SUBMITTAL SUMMARY REPORT MajorSite-000431-2026

PLAN NAME:	BLCCDD Warehouse	LOCATION:	8851 SW 90TH ST OCALA,
APPLICATION DATE:	02/27/2026	PARCEL:	35300-400001
DESCRIPTION:	This project will consist of the construction of a warehouse and maintenance facility to serve the Bay Laurel Center Community Development District.

SUBMITTAL	STARTED	DUE	COMPLETE	STATUS
OCE: Plan Review (DR) v.1	02/27/2026	03/13/2026	03/20/2026	Requires Re-submit
OCE: Plan Review (DR) v.2				Not Received

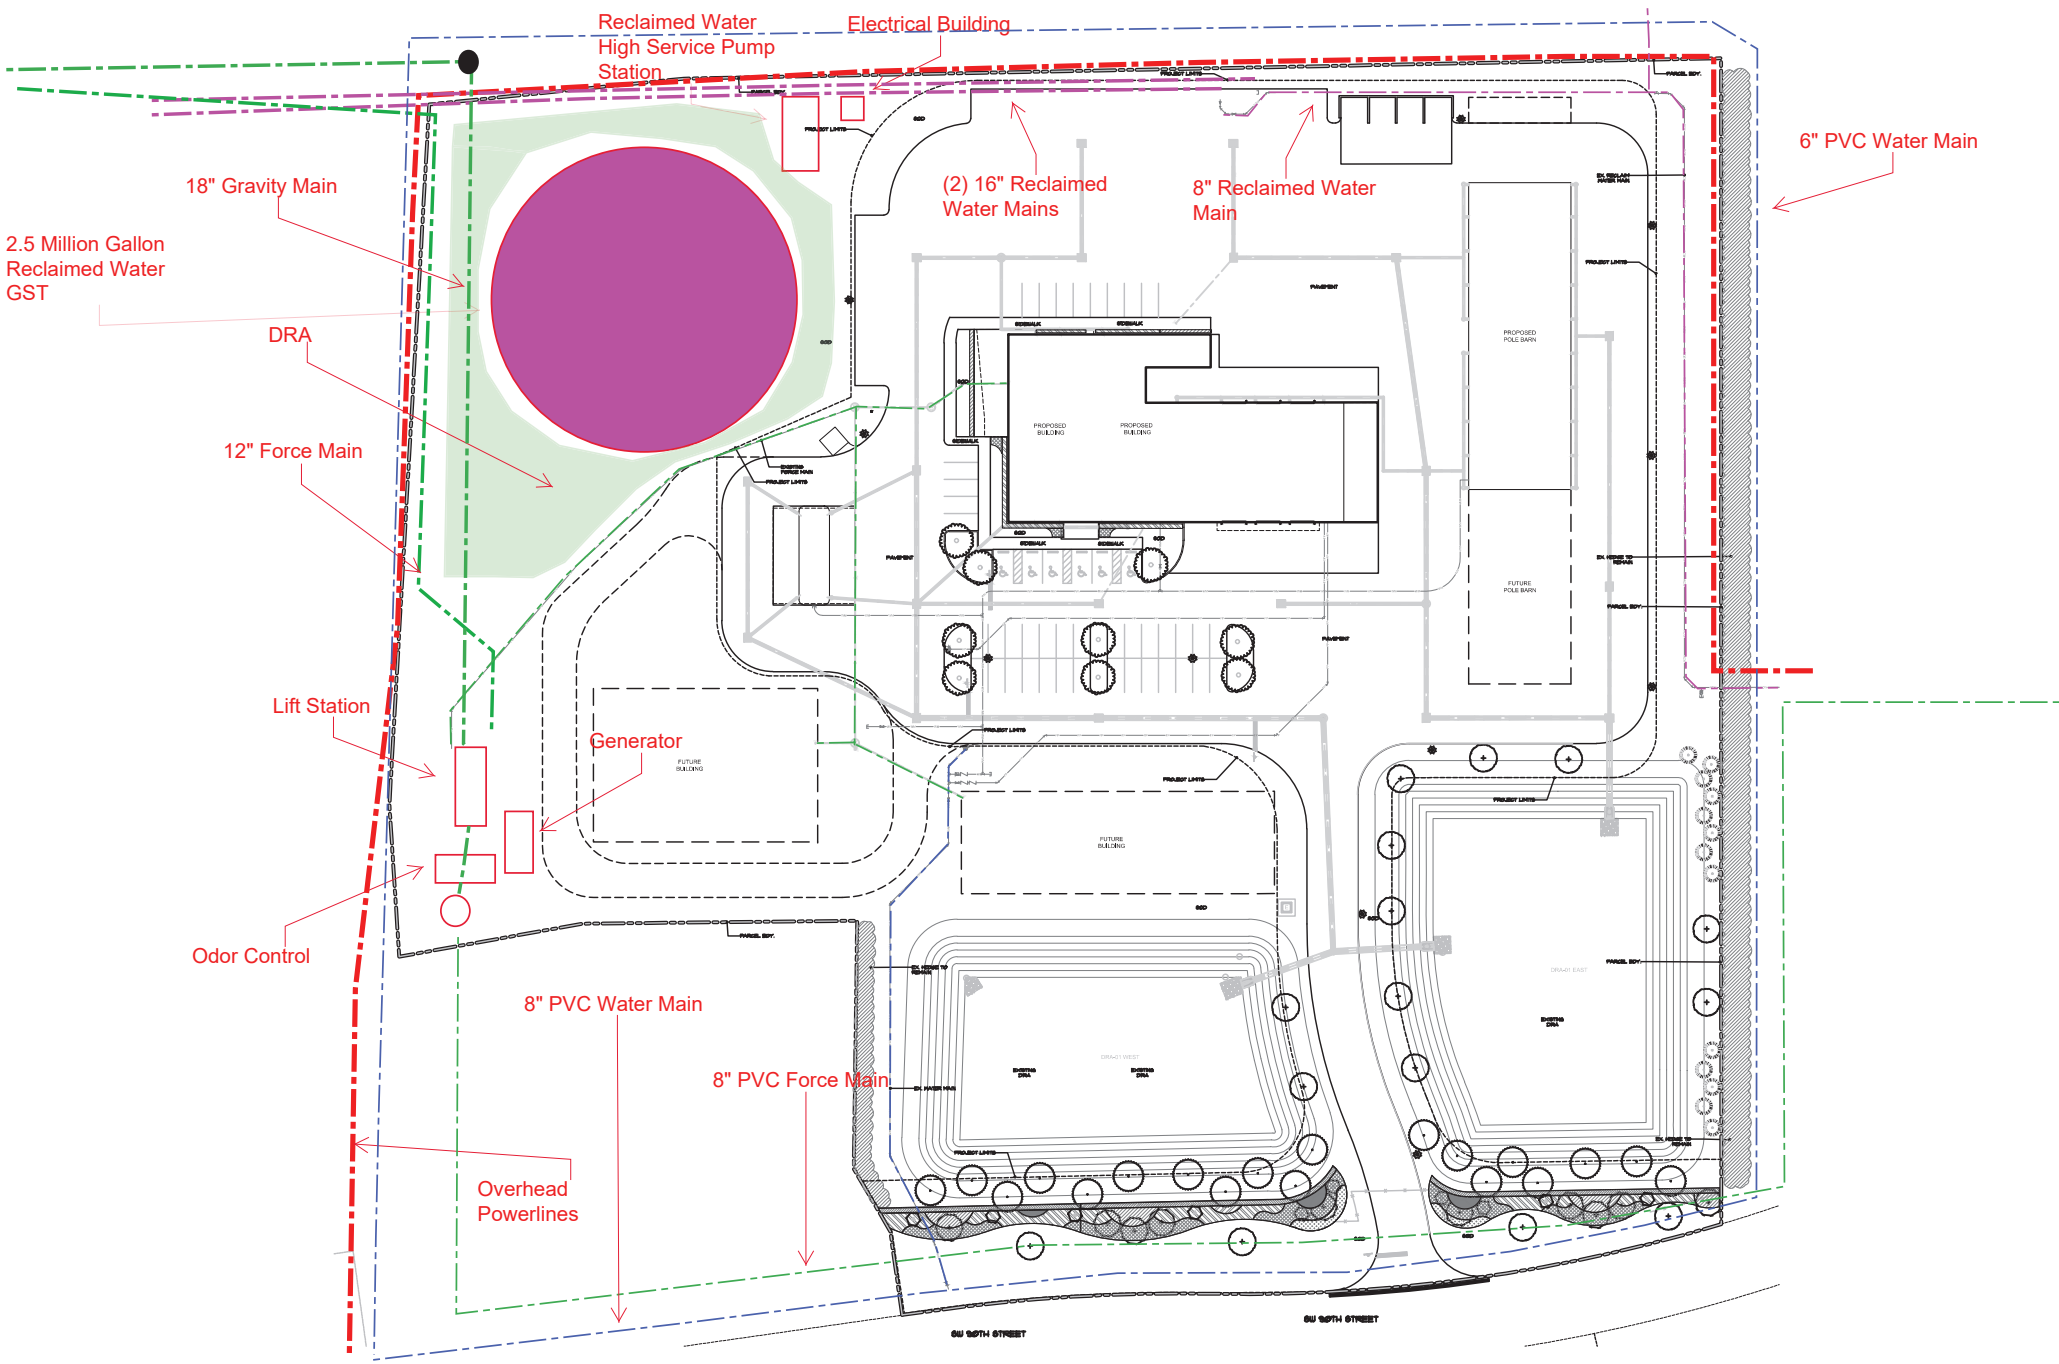
Section & Title of Code (be specific): _____ Section 6.7.4. - Shade Trees
Reason/Justification for Request (be specific): Code states: Shade trees to be provided at one per 3,000 -SF.
Proposed: We are proposing a reduction of the shade trees required by 25%.
Our justification is that there are many conflicting utilities on-site (submitted exhibit) and the site is previously developed without many existing shade trees.

DATE	
	DESCRIPTION	
	NO.	
	SHEET NO. BAY LAUREL FIELD OPERATIONS 90% CONSTRUCTION DOCUMENTS 840 SW 97TH STREET ROAD, SUITE 3, OCHA, FL 34481	EXISTING CONDITIONS AND DEMO PLAN
	PROJECT: BAY LAUREL COMMUNITY DEVELOPMENT DISTRICT SHEET NO. 142837006	12 SEPT 2025 142837006 KHA KHA AS SHOWN

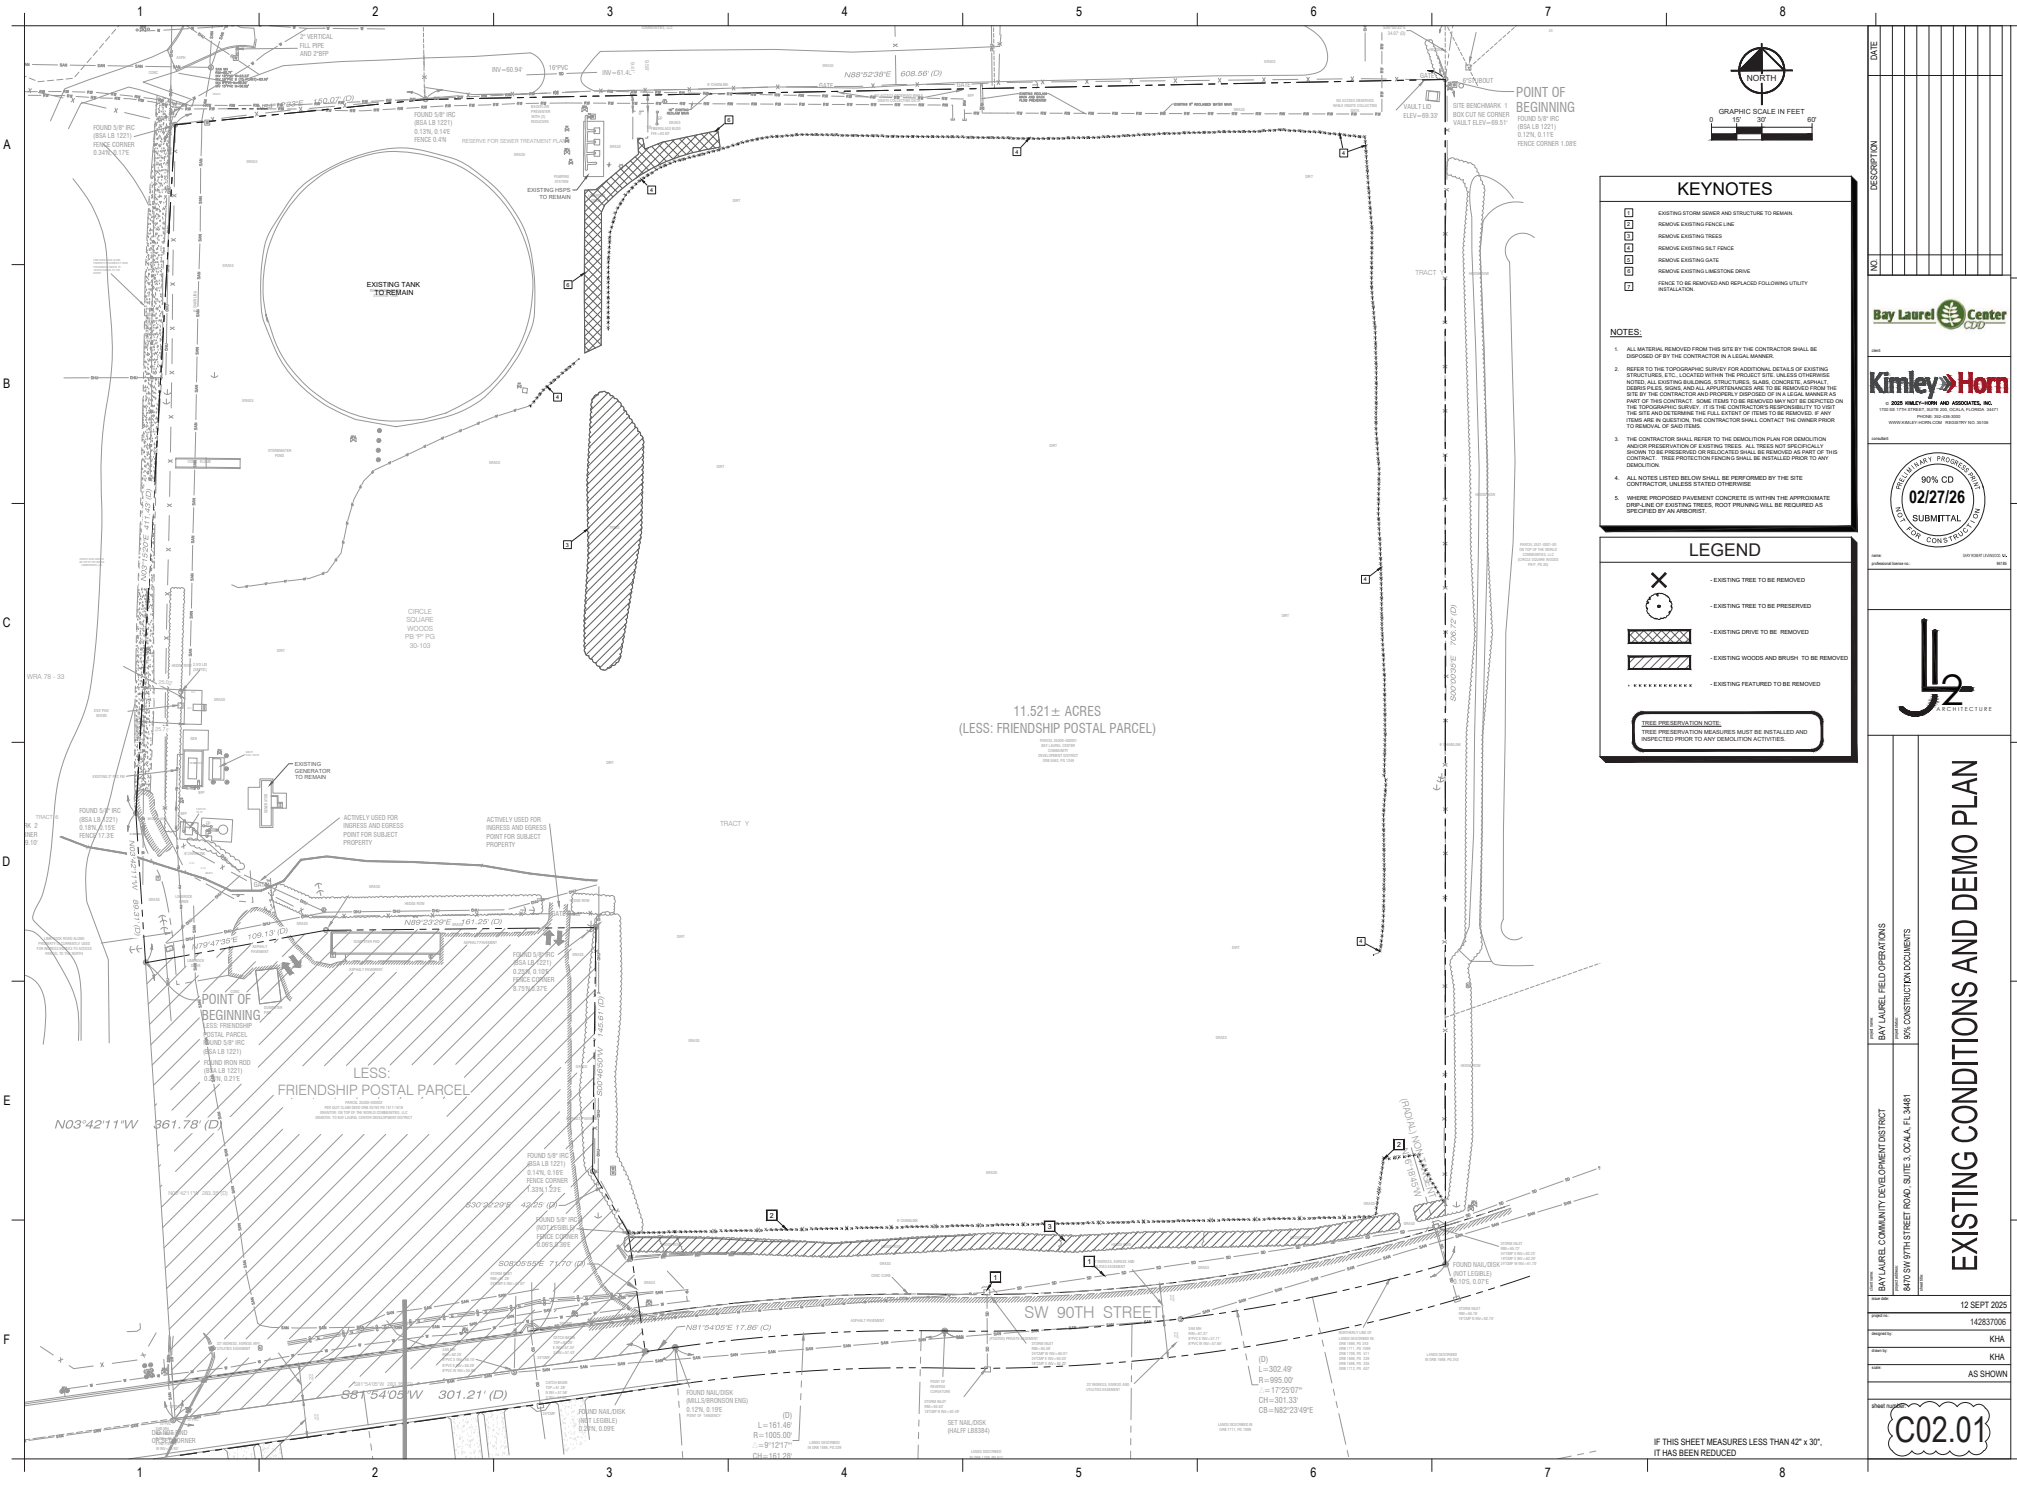
We are proposing a waiver to this code for the northwestern parking area (directly east of the existing tank). As there
is an existing established hedge row on the perimeter of SW 90th Terrace Road and the parking area is located directly behind the existing tank.
